CITY PLANNING COMMISSION

APPLICATION: Variance for six off-site parkings at an approved 11 space parking lot.

LOCATION: 2009 Wentworth Avenue

PROPOSAL: To provide six required parking spaces off-site for minor remodeling of Savings and Loan, under construction.

LAND USE 000992

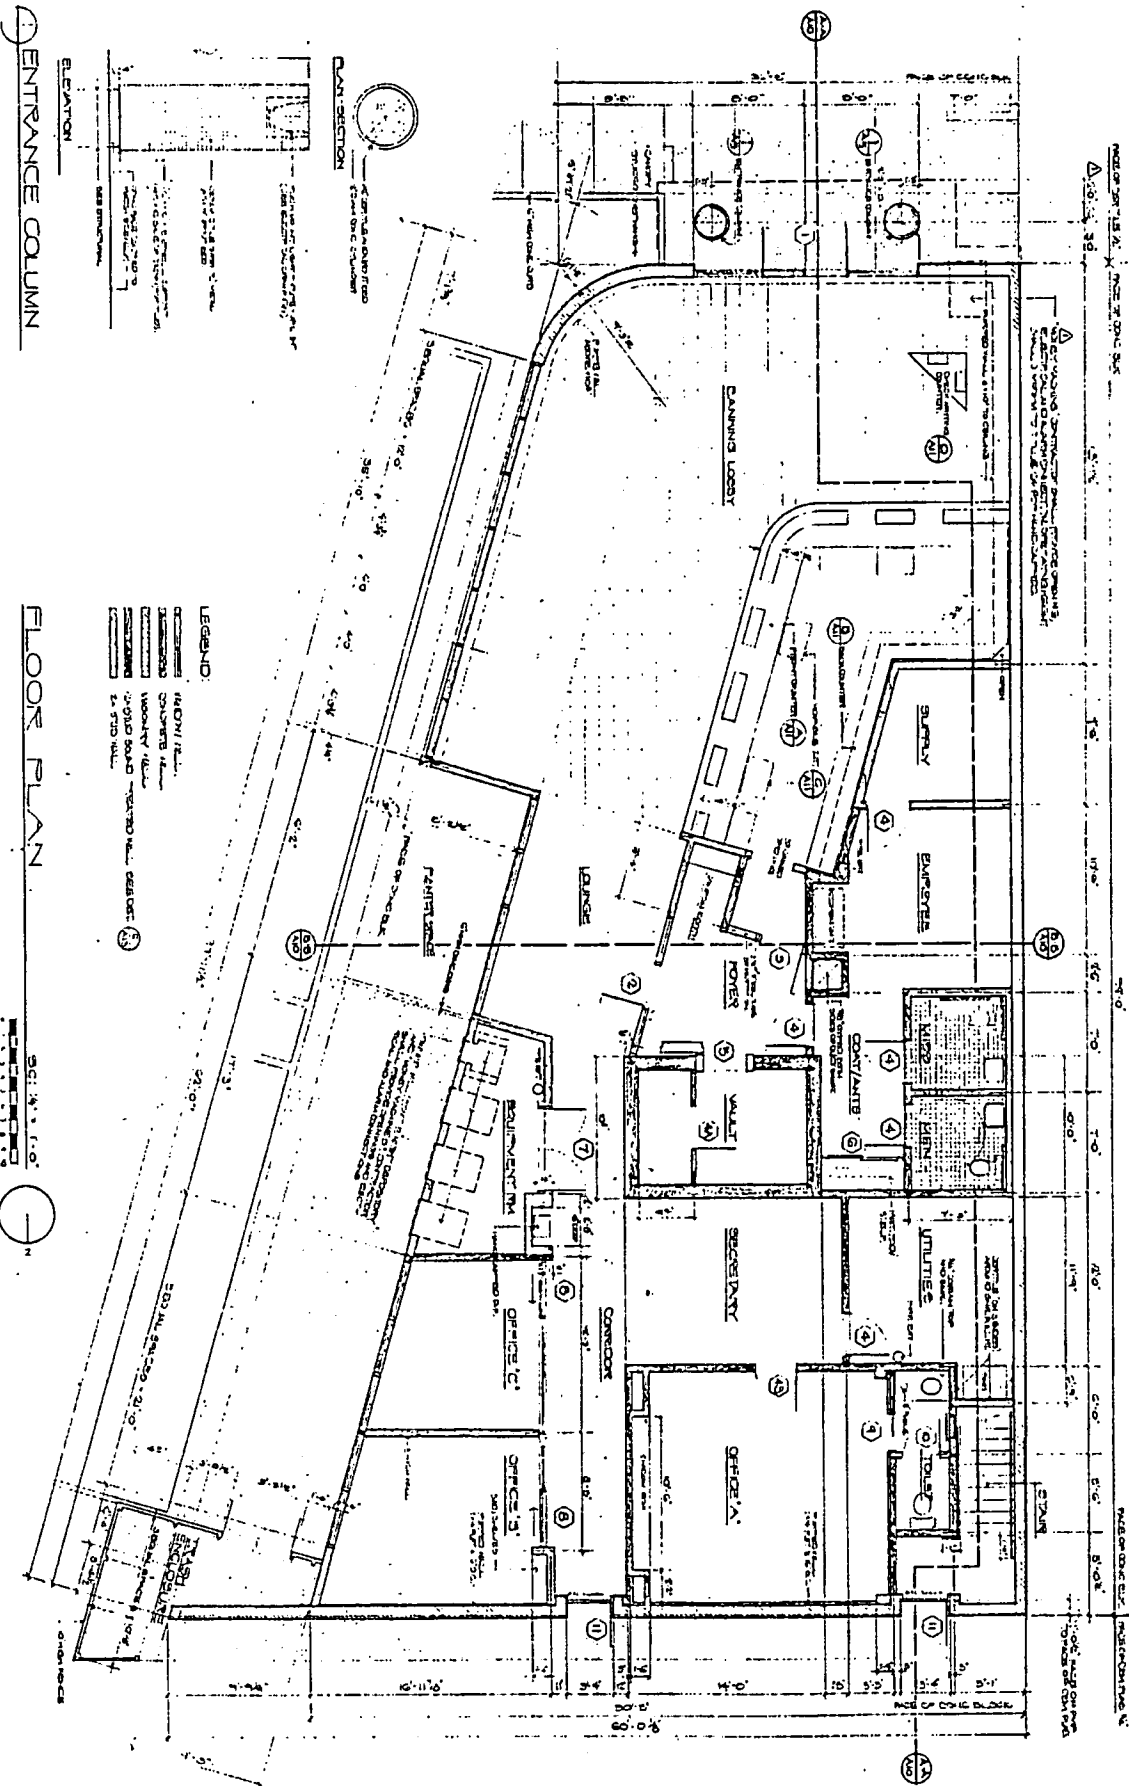
2. The submitted site plan for the Savings and Loan indicates a different configuration of the main parking area (See "Proposed Changes"). This is to accommodate handicapped access and weather protected automatic teller machines at the Freeport entrance. This change reduces the parking spaces on-site from 15 to 12. Staff recalculated the parking ratio and additional square footage per the revised parking design and determined that only four spaces instead of six spaces will be required off-site. A total of 16 spaces are required for the existing and proposed addition. The revised parking design provides 12 spaces. The remaining four required spaces will be located off-site. (See Land Use Plan)

LANDSCAPE PLAN

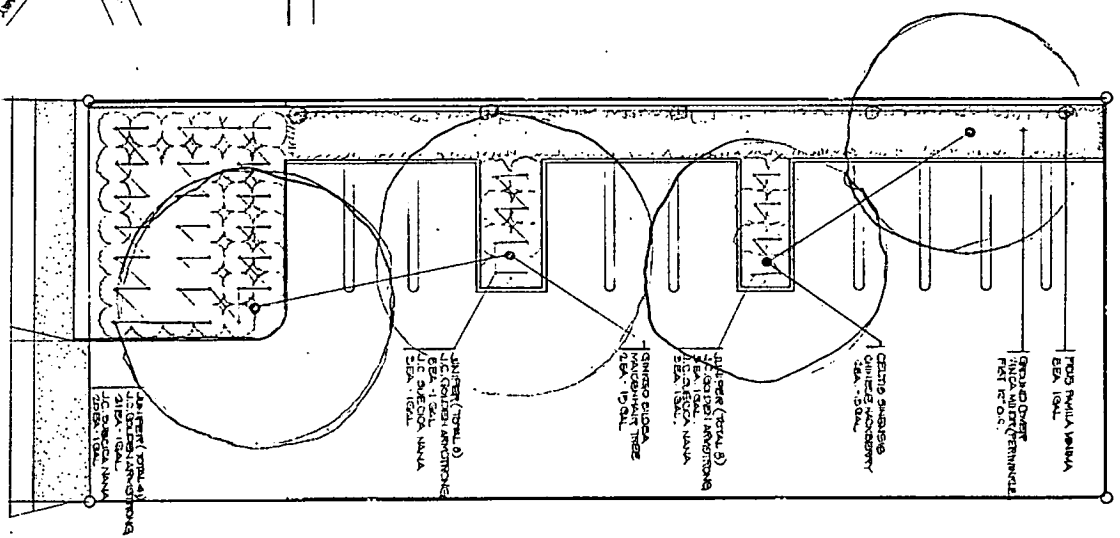
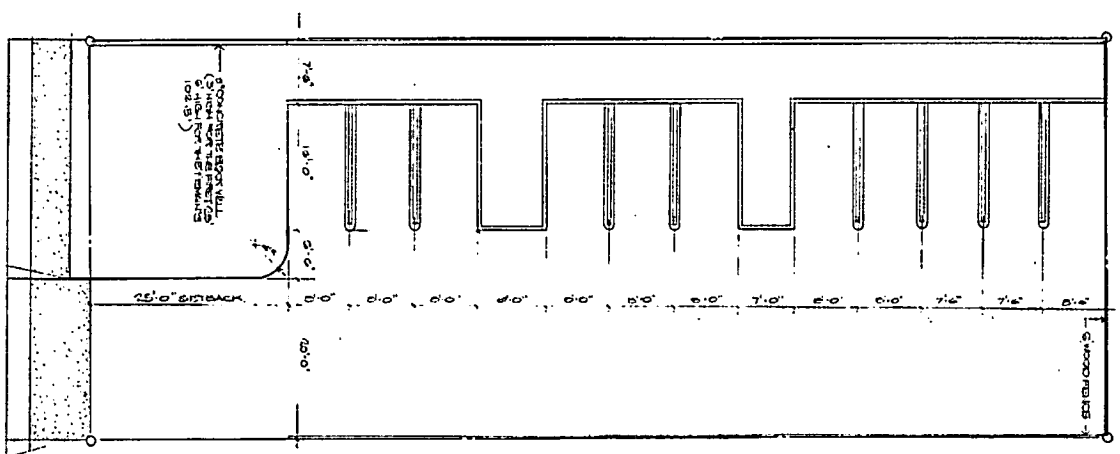
4. Staff is concerned about the adequacy of the proposed landscaping that will abut the adjacent residential property. Staff suggests that two additional trees be provided along the masonry wall (see Exhibit B) to achieve a screening effect between the parking lot and residential development. The three trees should be broadleaf evergreens to assure a year-round effect.

5. Staff is concerned with safety in the parking lot during hours of darkness. Security lighting would be necessary to mitigate the potential safety problem. Staff suggests that low height fixtures be used, or that if standard height fixtures are used, that they be oriented away from residential properties.

6. The Traffic Engineering Division indicates that a minimum 24-foot wide driveway is necessary. A site plan showing adjacent driveways and nearby fixtures, such as poles, hydrants, etc. must be submitted to Traffic Engineering in conjunction with the drive permit application process.

- a. Three broadleaf evergreen trees shall be planted as a year-round screen for the residential property to the west as indicated on Exhibit B;
- b. The applicant shall install security lights. A lighting plan indicating location and type and intensity of fixtures shall be submitted for staff review and approval prior to issuance of permits. Fixtures shall be low height or standard height, oriented away from residential properties;
- c. Detailed landscape and irrigation plans and shading plan shall be submitted for staff review prior to issuance of building permits.
